# CITY OF DE PERE

ADDENDUM NO. 1  
PROJECT 22-20  
AMERICAN BOULEVARD AND COMMERCE DRIVE CONCRETE PAVING

Notice is hereby given that the contract documents for the Project 22-20 are amended as hereinafter set forth. If you will be submitting a bid for Project 22-20, you must sign this addendum and include it with your submittal.

**ROCKLAND ROAD  
TRAFFIC CONTROL &  
PERMANENT SIGNING PLAN**

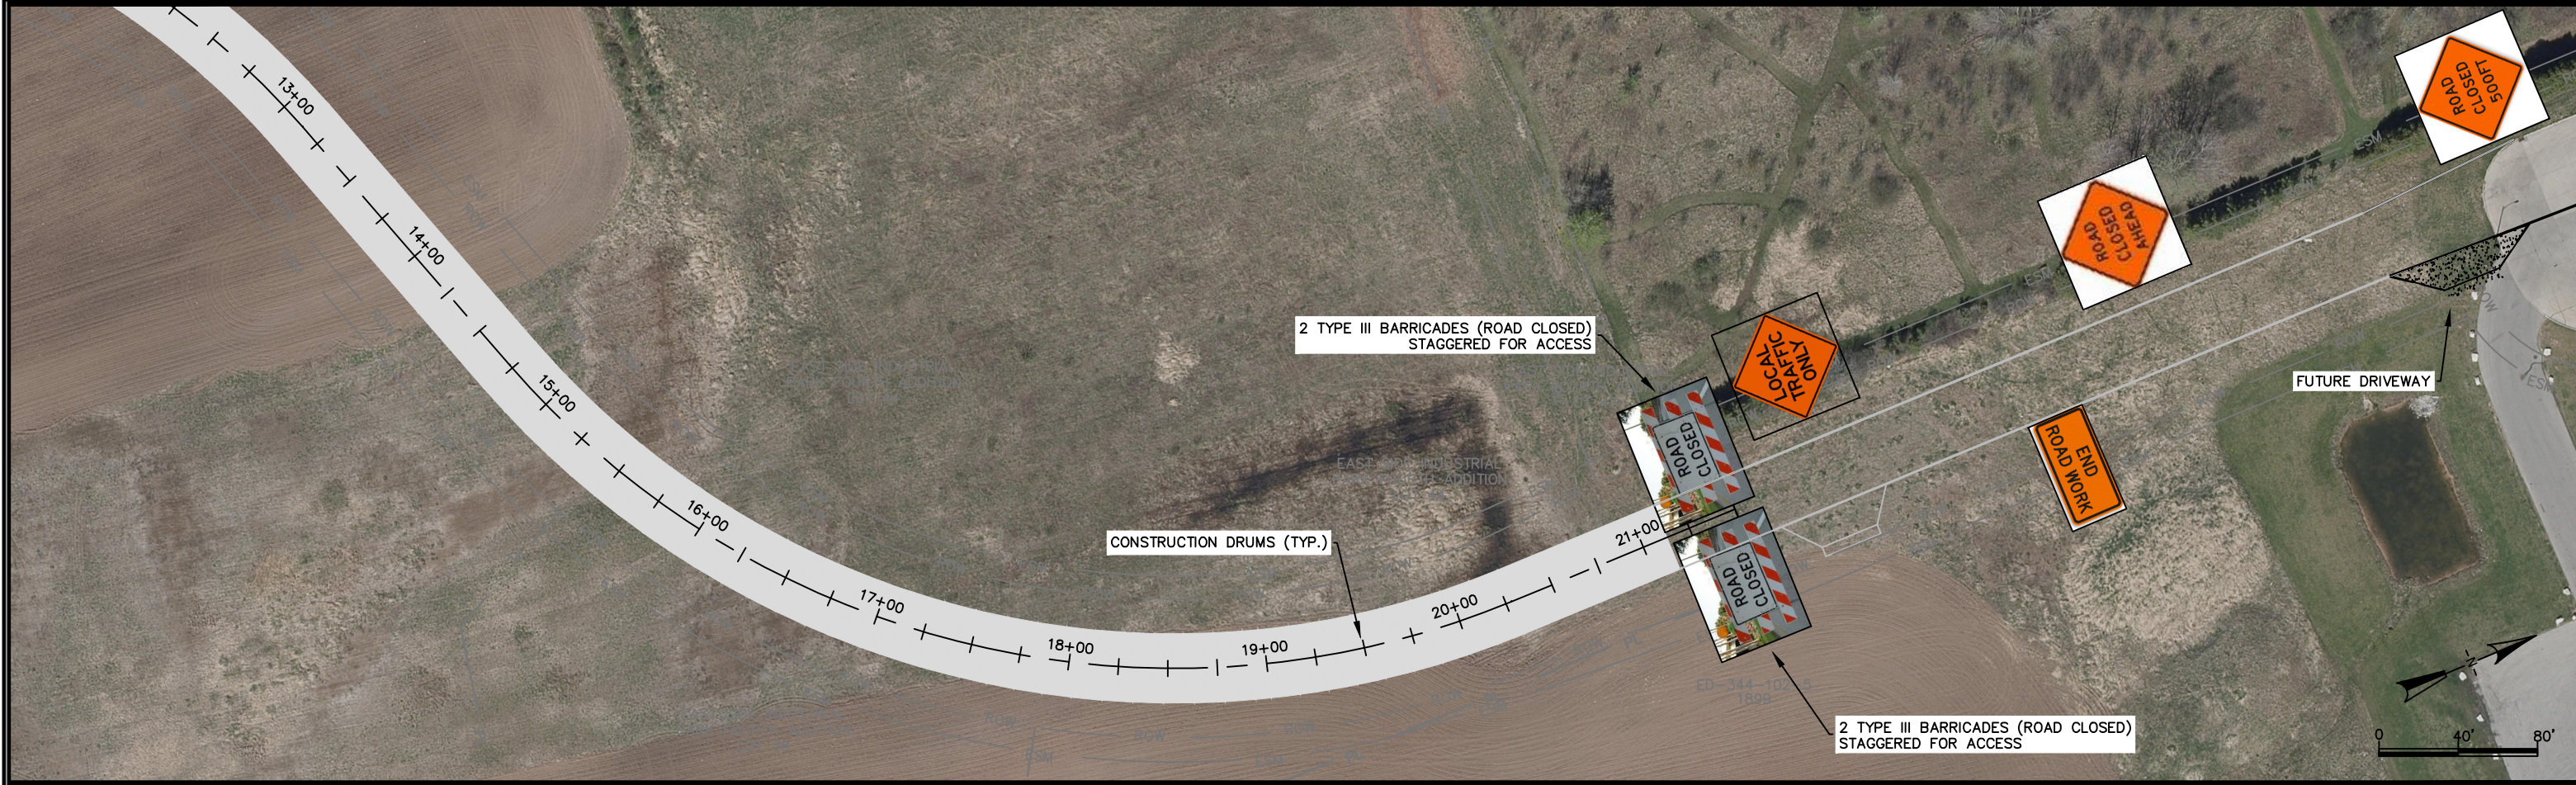
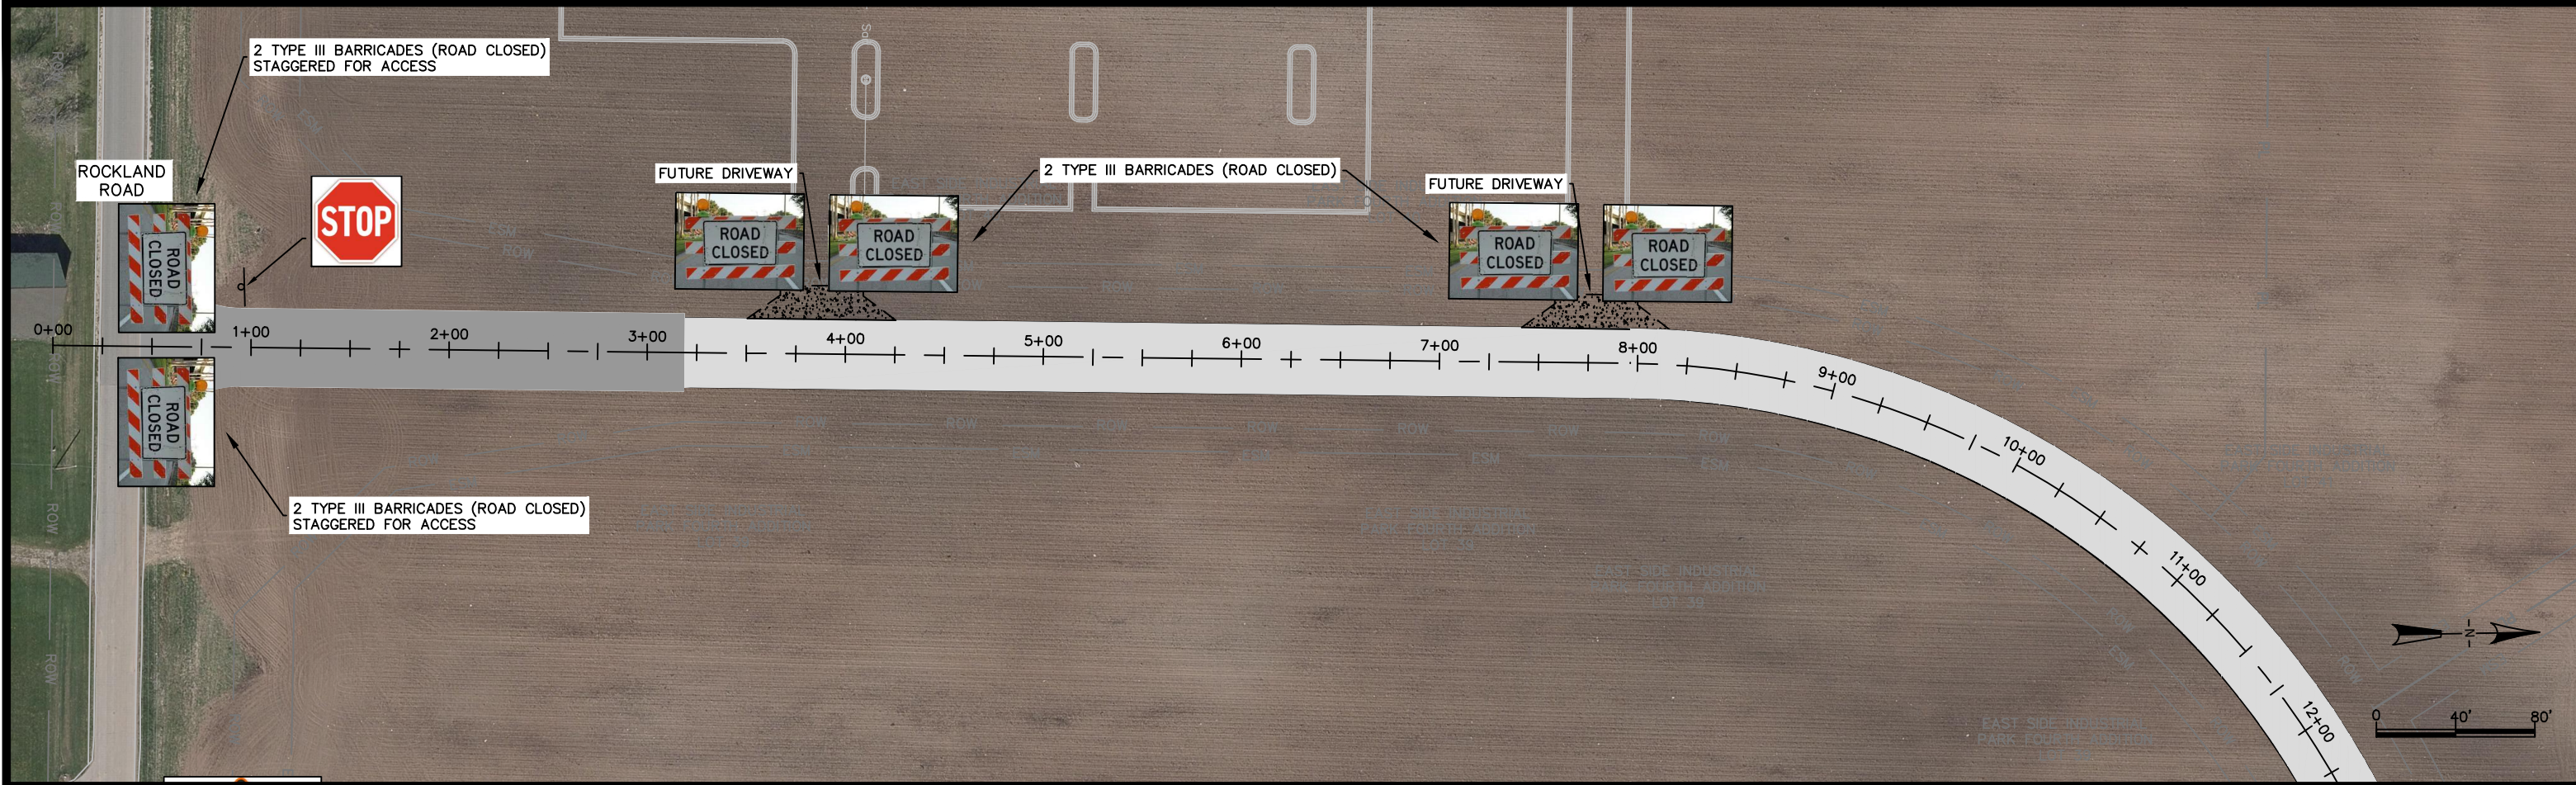
1. Delete Sheet C417 and insert Sheet C417R. The construction drums have been eliminated from Commerce Drive. Drums are not required because Commerce Drive will be closed to traffic. The contractor will be responsible to protect concrete during construction.

REVISIONS / ISSUES			
NO.	DATE	BY	REMARKS
1	02-2022	MAL	REMOVED CONSTRUCTION DRUMS
